SUBJECT: Lakeview Status Report

Oregon Department of Energy
Comments on the Draft Remedial Action Plan
Lakeview, Oregon

RESPONSE TO
NRC COMMENTS DATED JUNE 19, 1985
ON
LAKEVIEW ENVIRONMENTAL ASSESSMENT
LAKEVIEW (D) REMEDIAL ACTION
LAKEVIEW (D) PSCR, AND
LAKEVIEW (D) DSCR (COLLINS RANCH SITE)

Response to Comments Lakeview RAP, EA, and Collins Ranch DSCR

FIGURE 19.5. Curves showing the relationship between bearing-capacity factors and ϕ , as determined by theory, and rough empirical relationship between bearing capacity factors or ϕ and values of standard penetration resistance N .

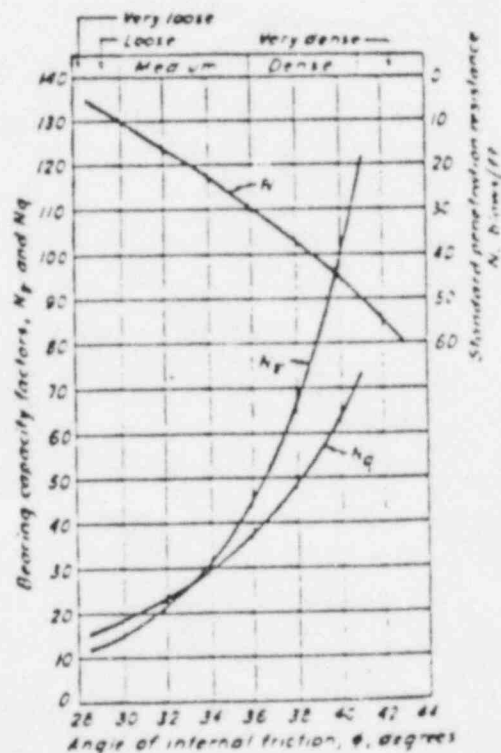
1. Comment

Blow counts were correlated to strength using Figure 19.5 from Peck Hansen and Thornburn (copy attached). The average blow count in the upper foundation soils was 36 and that of the lower foundation soils was 53. Laboratory tests were run on silt (MH) soils from these zones with resulting PHI angles of 38 degrees and 41.5 degrees. Subsequent laboratory testing resulted in effective PHI angles of 39.5 degrees for a silty sand with gravel and 36.7 degrees for a similar material obtained from the deeper layer. Based on the triaxial test data, it is considered that the strength parameters selected are realistic for the materials encountered, and that an effective PHI angle of 38 degrees is conservative and appropriate for both layers.

DISTRIBUTION OF SULFATE CONCENTRATION vs.
SULFUR-34 ISOTOPE RATIO

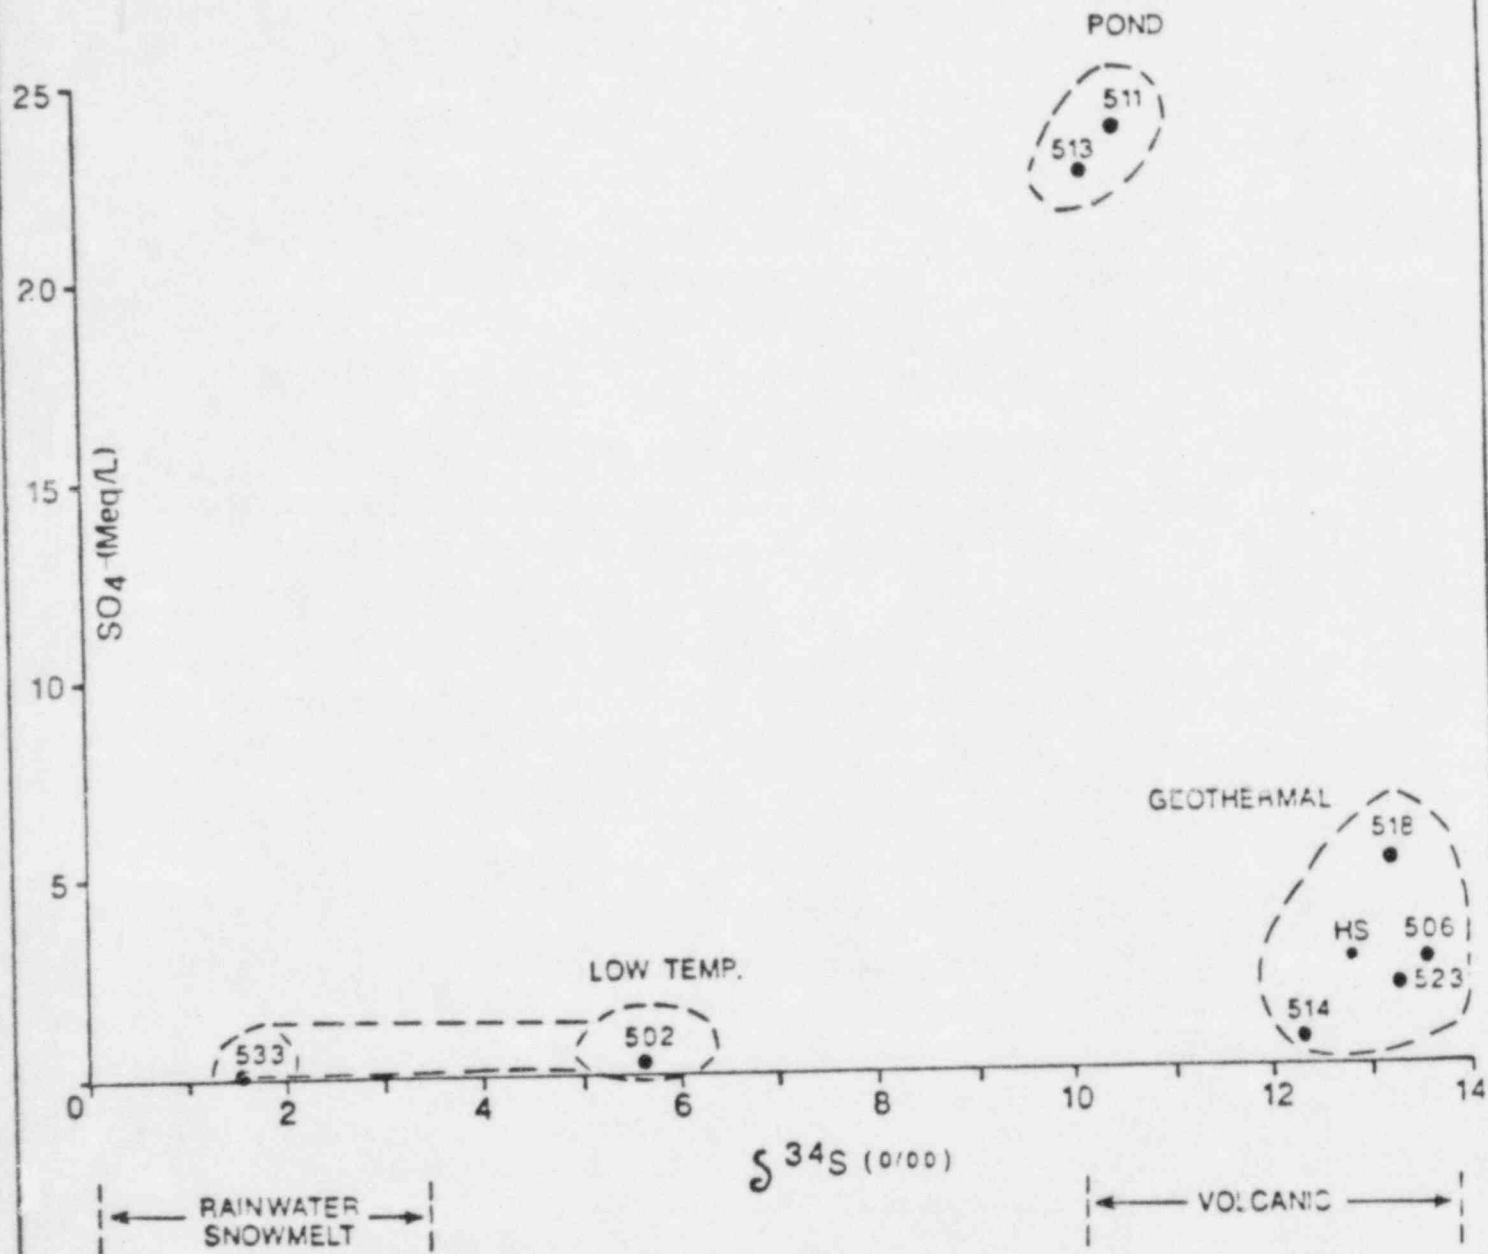
Comment

Shallow ground water was collected from wells completed at 20 to 25 feet below land surface and deep ground water at depths greater than 70 feet. The attached figure clearly shows that the downgradient samples cluster with the background, geothermal samples, indicating that the high dissolved solids found downgradient originated from the geothermal system rather than the pond leachate.

This information will be added to the LKV PSCR and RAP/SCD as applicable.
